Addition of insertion chamfers on the mating face of the SL 5.08HC

Type of notification: PCN PDN Short-term action (<6 months)

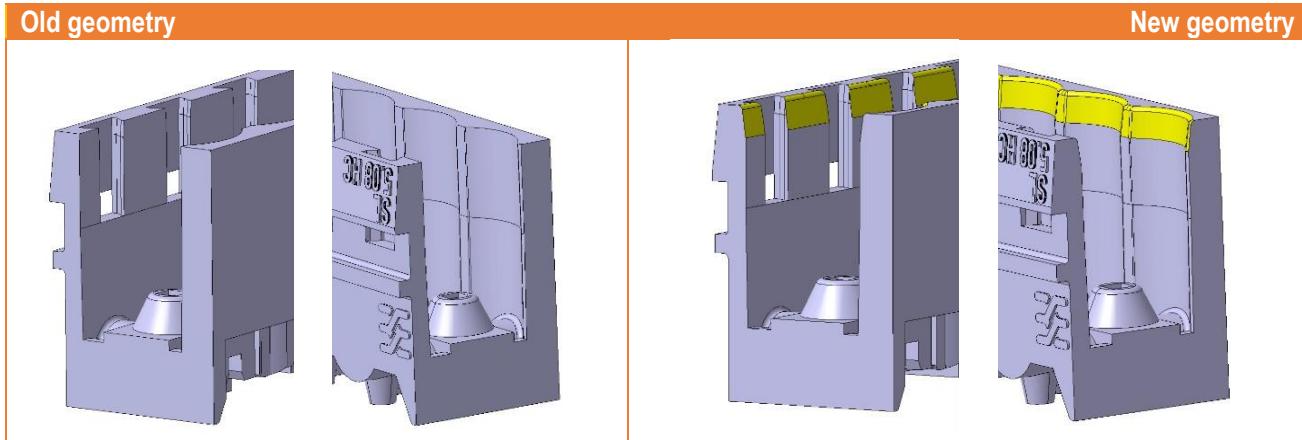
The SL 5.08HC pin headers are delivered with an optimized geometry. The mating face has been supplemented by an insertion chamfer (yellow marked area in the pictures). This change simplifies mating between the male header and the counter part.
